## Field Monitoring Report -- Pebble Copper/Gold Exploration Project --

Personnel:	Inspection Date: August 3, 2010
Bill Cole, DNR, Mining Section	Site Contact: Jim Male, Jeff Norberg
Melinda O'Donnell, DNR, DCOM	APMA #: A106118
<b>■ Inspection Type:</b> <ul style="list-style-type: none"> <li>○ Complete: Inspected two active drill rigs, the Big Wiggly Fuel facility, and five abandoned drill sites.</li> <li>○ Partial:</li> <li>○ Follow-up:</li> <li>○ Response to Public Complaint:</li> </ul>	<b>■ Wildlife Observed:</b> <ul style="list-style-type: none"> <li>○ Bear: Two brown bears observed along Upper Talarik Creek</li> <li>○ Caribou: Six caribou sighted near Frying Pan Lake</li> <li>○ Moose: None</li> <li>○ Waterfowl: None</li> <li>○ Fish: None</li> <li>○ Other: Various birds</li> </ul>
<b>■ Weather Conditions:</b> <ul style="list-style-type: none"> <li>○ Temperature: Approximately 50° F</li> <li>○ Wind: 20-25 mph</li> <li>○ Precipitation: None</li> <li>○ Visibility: 10 miles, except where obscured by clouds</li> <li>○ Sky Conditions: Overcast, cloud ceiling around 3,000'</li> <li>○ Ground Conditions: Dry</li> </ul>	<b>■ Water level at Frying Pan Lake: Full</b> <ul style="list-style

Figure #2. Drill #3 on DDH 10497. Note tundra pads.

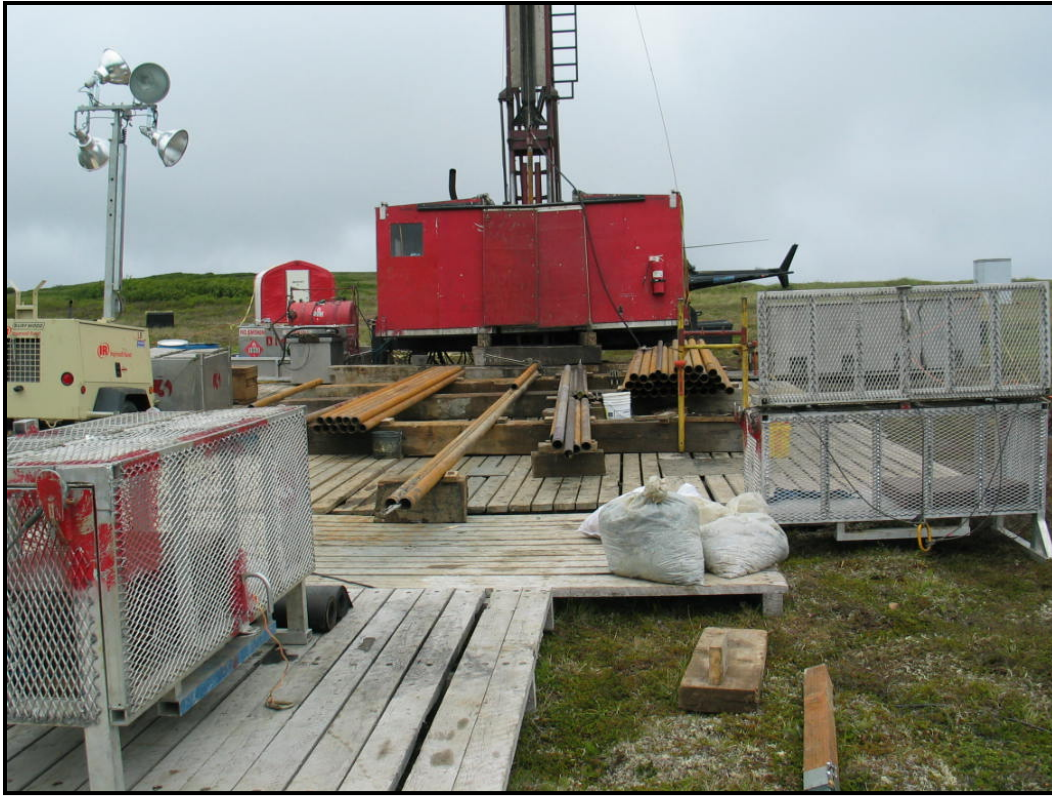
Drill Hole/Site No.: DDH 10497	Rig No.: 3
Activity: Drilling, about 900'	Date: 8/3/10
<p>■ Condition of Drilling Site:</p> <ul style="list-style-type: none"> <li>○ Distance from waterbody: 1,200'</li> <li>○ Location of fuel storage: Adjacent to drill</li> <li>○ Sorbent pads present: Yes</li> <li>○ Tundra mat: Yes</li> <li>○ Pipe off tundra: Yes</li> <li>○ Litter: None</li> <li>○ Trash containment: Yes</li> <li>○ Sanitary facilities: Yes</li> <li>○ Any spills or staining: No</li> <li>○ General impression: Clean site</li> </ul>	<p>■ Sump Pit (continued):</p> <ul style="list-style-type: none"> <li>○ Location and extent of discharged material: Discharge approximately 300' west, uphill from the drill. Extent of discharge unobserved.</li> <li>○ Topsoil, muck, tundra stockpiled: Yes</li> <li>○ Location of secondary sump pit: See above</li> <li>○ Hose color: White</li> </ul>
	<p>■ Drill Water Supply:</p> <ul style="list-style-type: none"> <li>○ Stream, lake, kettle pond: Stream</li> <li>○ Location: 1,200' west of drill</li> <li>○ Adequate water flow and depth for fish passage in streams: Yes</li> <li>○ Evidence of significant impacts to riparian vegetation or stream banks: No</li> <li>○ Relative water level: full</li> <li>○ General impression of water body, i.e. clear, turbid, tannic: clear</li> </ul>

<p>■ Drilling Activity:</p> <ul style="list-style-type: none"> <li>○ Drill additives in use: See comments above</li> <li>○ Water recirculation: Yes</li> <li>○ Water discharged: Yes, periodically as needed</li> <li>○ Artesian zone encountered: None</li> </ul>	<ul style="list-style-type: none"> <li>○ Intake structure: Yes</li> <li>○ Structure clear of debris: Yes</li> <li>○ Mesh size: Unknown</li> <li>○ Submerged: Yes</li> <li>○ Pump location to source: 100' uphill</li> </ul>
<p>■ Sump Pit:</p> <ul style="list-style-type: none"> <li>○ Location: North side of drill</li> <li>○ Discharge trench: Yes</li> <li>○ Dimensions of pit: 3 pits: all 5'X10'X5'</li> <li>○ In use: Yes</li> </ul>	<ul style="list-style-type: none"> <li>○ Catch basin for fuel supply: Yes</li> <li>○ Sorbent pads: Yes</li> <li>○ Hose color: Yellow</li> </ul>

Figure #9. Discharge area from DDH 10498.

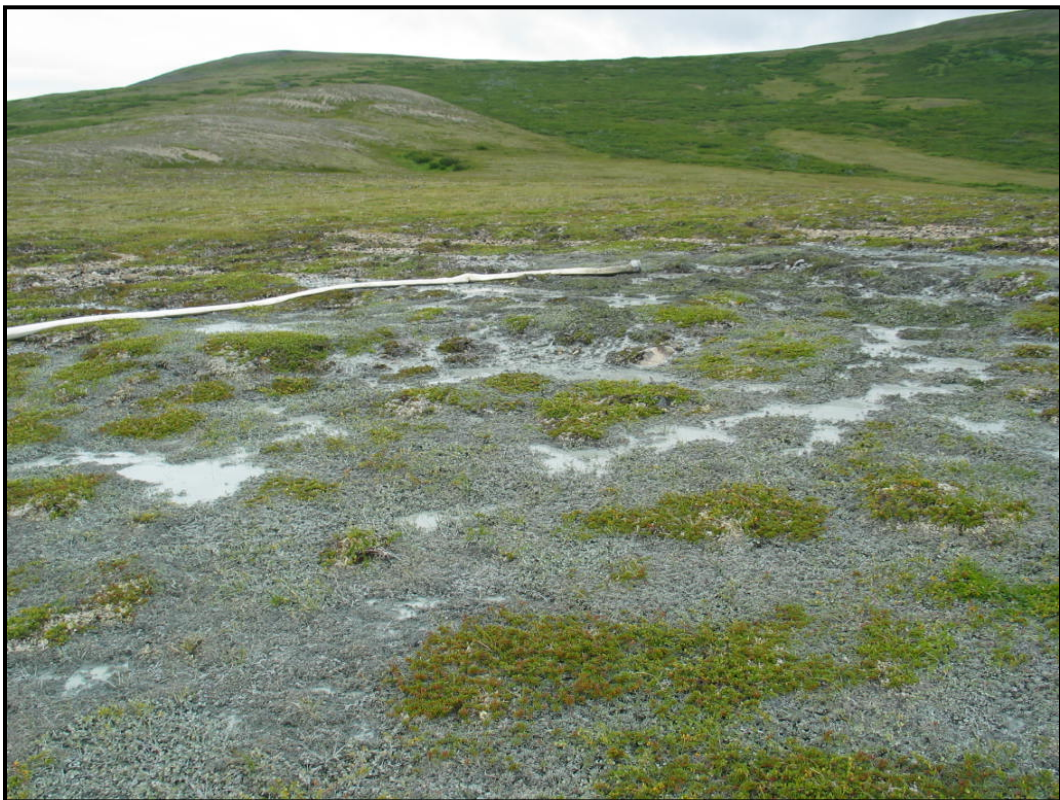
Drill Hole/Site No.: DDH 10498	Rig No.: 4
Activity: Drilling at 941'	Date: 8/3/10
<ul style="list-style-type: none"> <li>■ Condition of Drilling Site:</li> </ul>	<ul style="list-style-type: none"> <li>■ Sump Pit (continued):</li> </ul>
<ul style="list-style-type: none"> <li>○ Distance from waterbody: 550'</li> </ul>	<ul style="list-style-type: none"> <li>○ Location and extent of discharged material: 600' to north, uphill from drill. Flowing about 200' downhill</li> </ul>
<ul style="list-style-type: none"> <li>○ Location of fuel storage: Adjacent to drill</li> </ul>	<ul style="list-style-type: none"> <li>○ Topsoil, muck, tundra stockpiled: Yes</li> </ul>
<ul style="list-style-type: none"> <li>○ Sorbent pads present: Yes</li> </ul>	<ul style="list-style-type: none"> <li>○ Location of secondary sump pit: See above</li> </ul>
<ul style="list-style-type: none"> <li>○ Tundra mat: Yes</li> </ul>	<ul style="list-style-type: none"> <li>○ Hose color: White</li> </ul>

Figure #13. DDH 9464 reclamation.

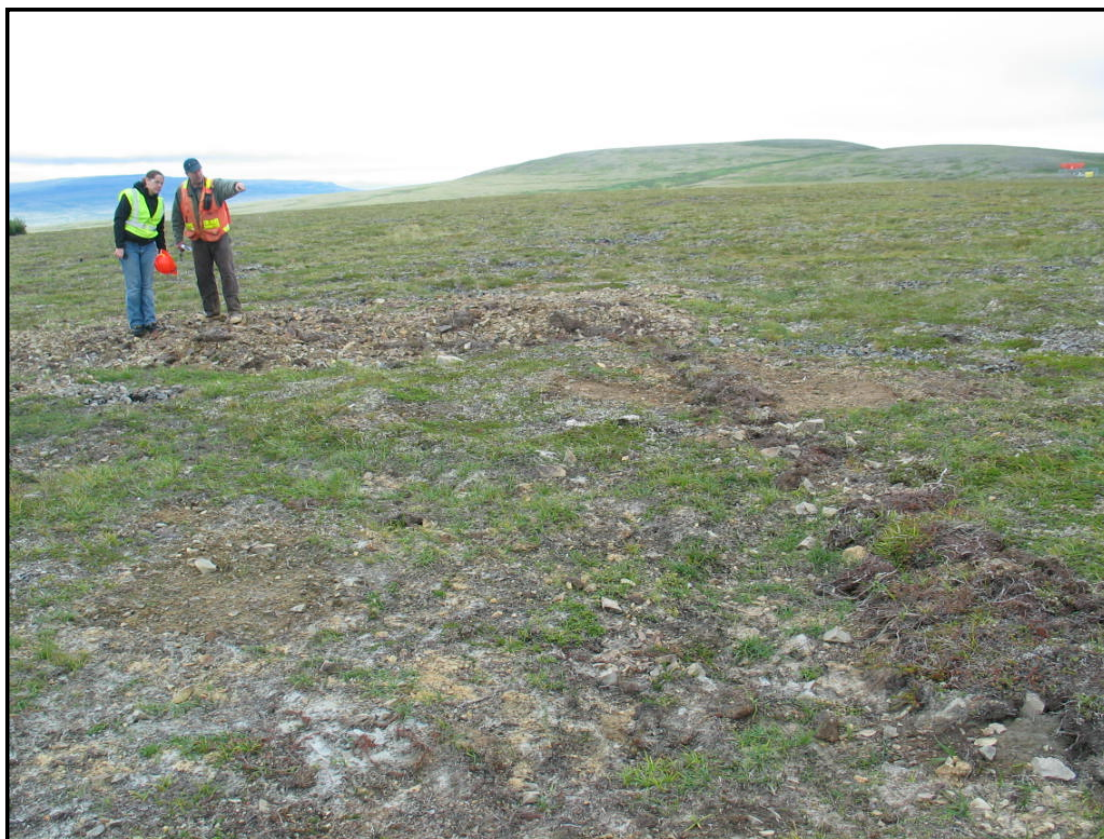
■ Comments/General impression: Area around hole is rocky, with little soil or vegetation. Tundra has been replaced to extent possible, and some is surviving. In other areas there is some revegetation occurring, but much of the site has not revegetated.

**Recommendations:** DNR and Pebble Partnership personnel will research better methods of reclaiming drill sites on rocky ground. Early consultations with industry consultants indicate that 5-10 years is a reasonable time to expect revegetation of disturbed tundra. Over time, the tundra will revegetate on its own; however, it may be possible to enhance revegetation by seeding or fertilization.
